To: Steve Teel, Department of Ecology

From: Tasya Gray, Taylor Way and Alexander Avenue Fill Area (TWAFA) Agreed Order Potentially Liable Parties Group Project Coordinator, ngray@dofnw.com

Subject: Ecology October 13, 2022 email regarding “Comments on TWAFA reports and request for work plan”

Ecology comments on first and second quarter 2022 groundwater monitoring reports and the recent sub-slab soil vapor sampling results from the Former Potter Property.

Figure
Property Features and
Vapor Sample Locations

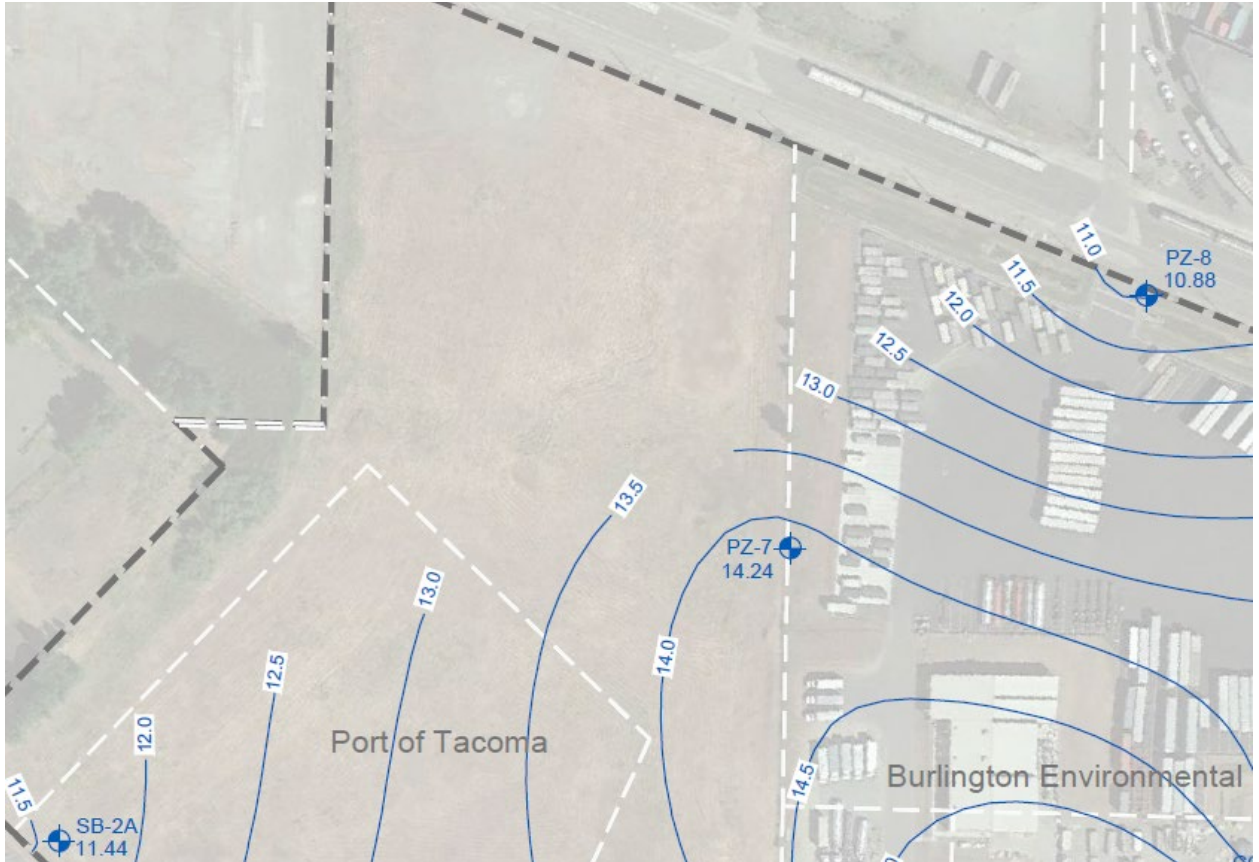
5. **Additional Characterization – Former Potter Property:** In addition to the new well and associated soil samples mentioned above, additional soil and soil vapor sampling are needed to further investigate the elevated sub-slab concentrations that were observed beneath Quonset Hut 2 and the Shop Building on the Former Potter Property (Figure 1):

- a. **Quonset Hut 2, location TWA-SV-35:** Soil samples for total petroleum hydrocarbons, gasoline, diesel, and oil range organics (TPH-G, -D, and -O); volatile organic compounds (VOCs); semi-volatile organic compounds (SVOCs, including carcinogenic PAHs, cPAHs); polychlorinated biphenyls (PCBs), and metals are needed to investigate the source of the elevated TPH sub-slab concentrations and any residual contamination.

- b. **Shop Building, location TWA-SV-41:** Soil samples for TPH, VOCs, SVOCs, PCBs, and metals are needed to investigate the source of the elevated TPH, PCE, and TCE sub-slab concentrations and any residual contamination. Additional sub-slab sample locations for TPH-APH and VOCs are also needed near the property line with Emerald Services to determine if there is a potential for elevated TPH and chlorinated VOCs soil vapor concentrations to be present beneath the adjacent Emerald Services building. If concentrations above applicable screening levels are found then sub-slab sampling beneath the Emerald Services Building will also be necessary.

(From Figure 3, 1st quarter 2022 groundwater monitoring report)

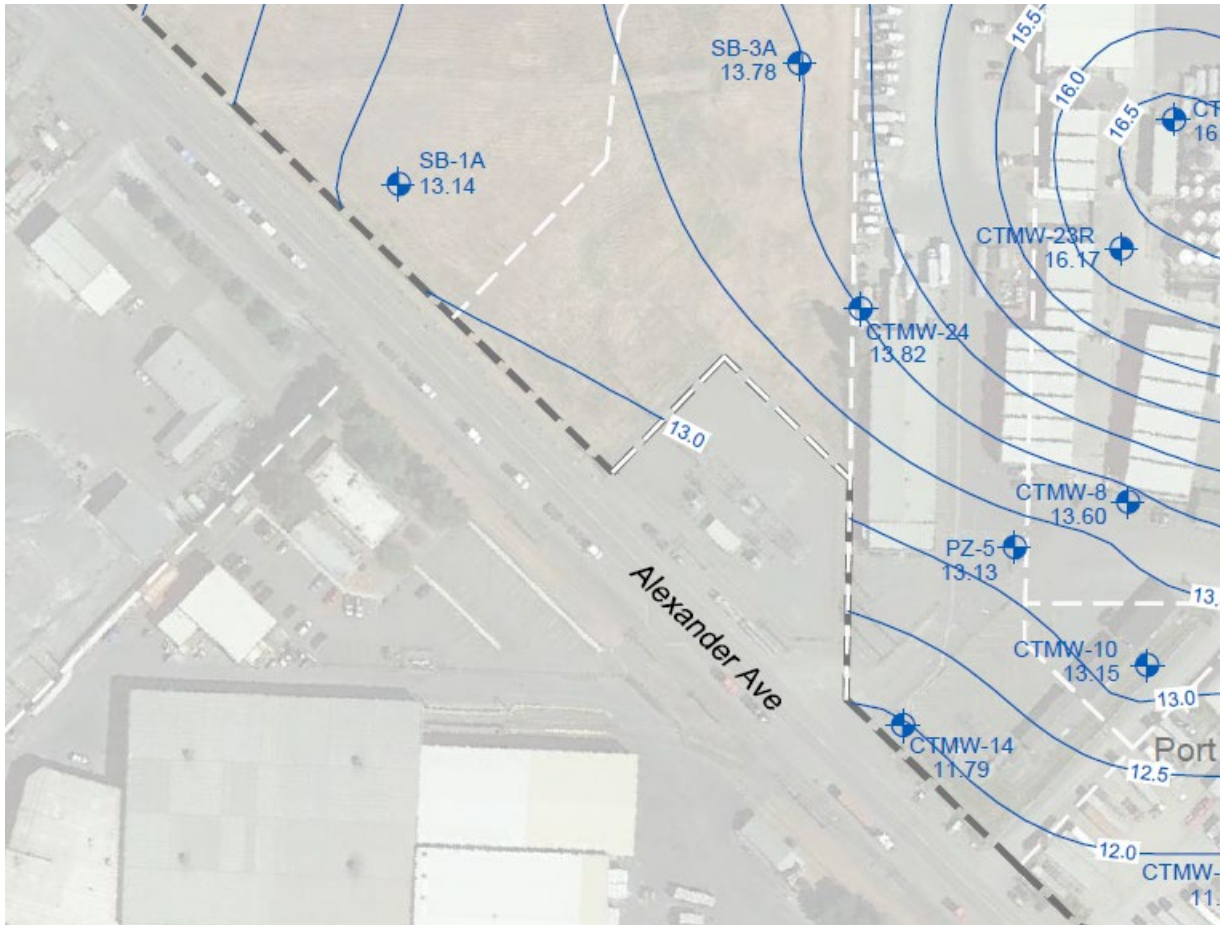
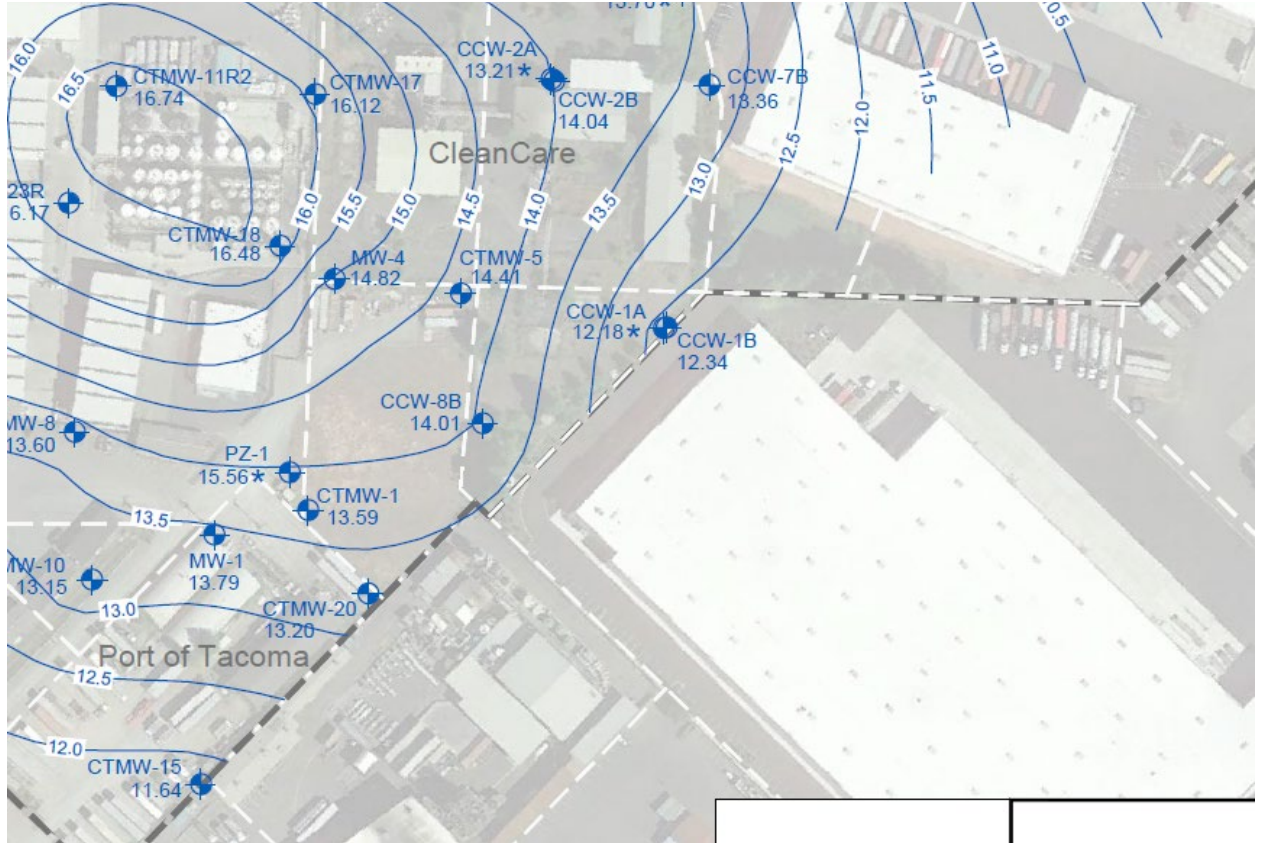
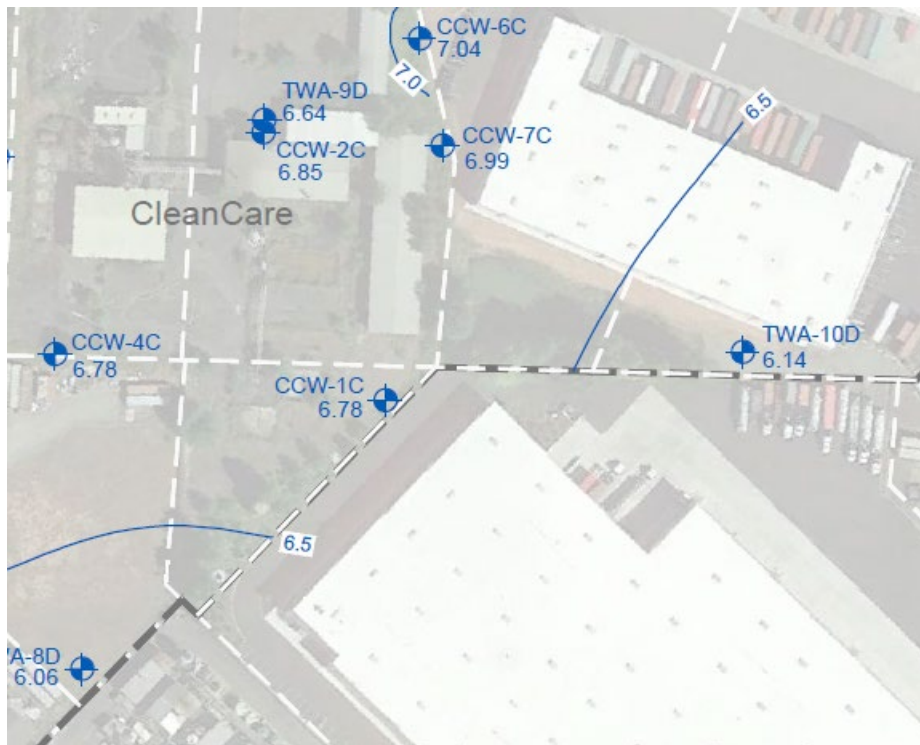
3. Groundwater elevation contour lines on figures should not stop at a parcel boundary but should be connected with a solid or dashed line when possible. Please ensure that this is done on future report figures. Examples where contour lines should have been connected are shown below:
